SAFETY RECALL BULLETIN

NHTSA RECALL 20V689

AUTOCAR, LLC SAFETY RECALL ACX-2008

Autocar has determined that certain 2020-2021 model year Xpeditor (ACX) and Legend (DC) chassis, may not have the transverse torque rod mounting bolts properly torqued.

Figure 1

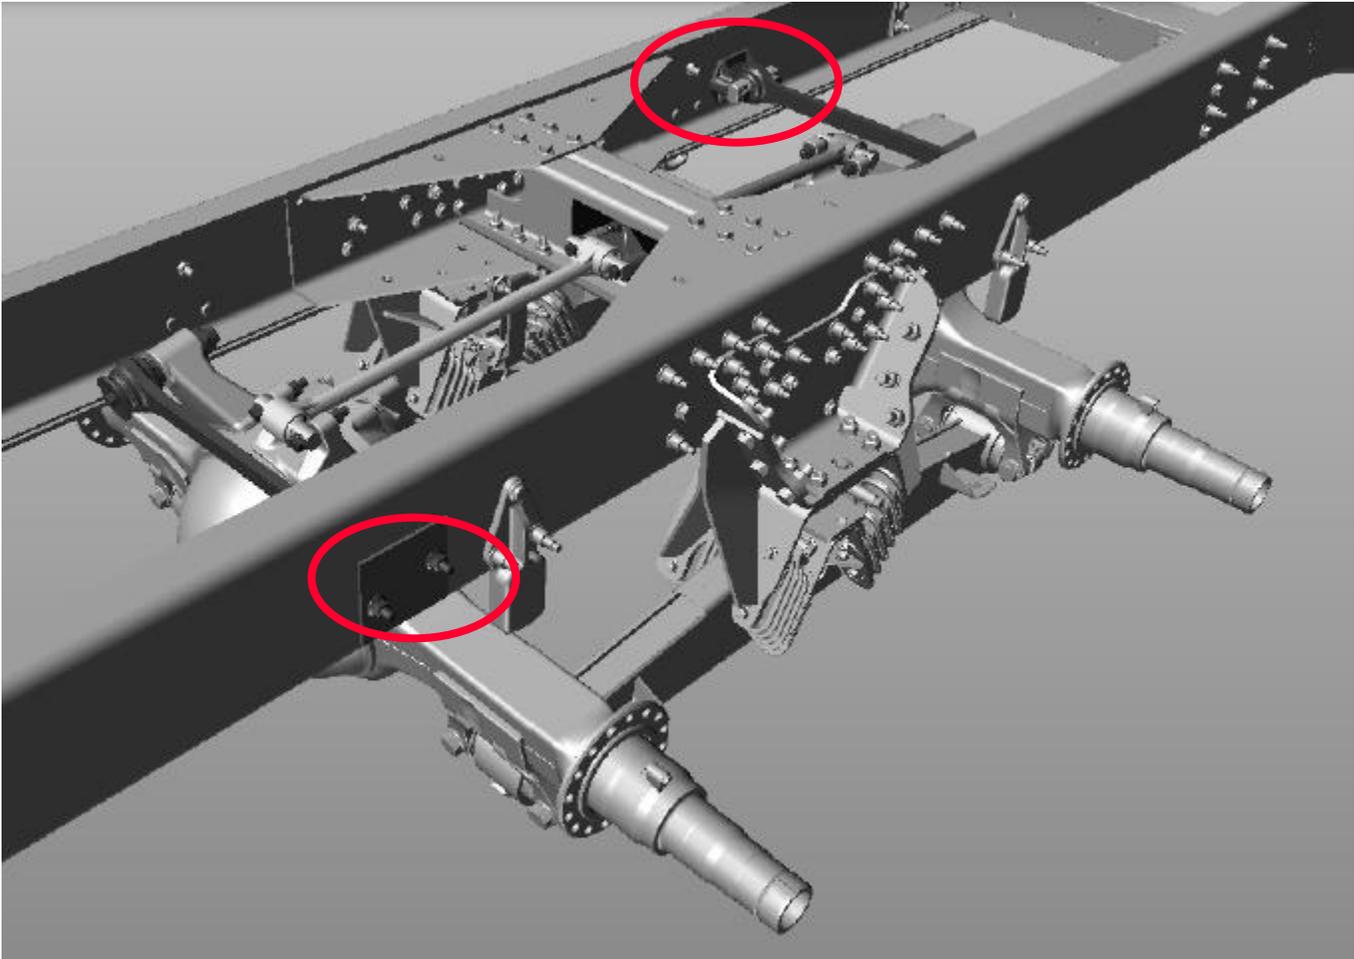
1. Locate the 2 nuts and bolts on each transverse torque rod, one on each side of the frame rail (see Figure 1).

2. Tighten the transverse torque rod mounting bolts to 170 lbs-ft of torque.
3. Repairs are complete.
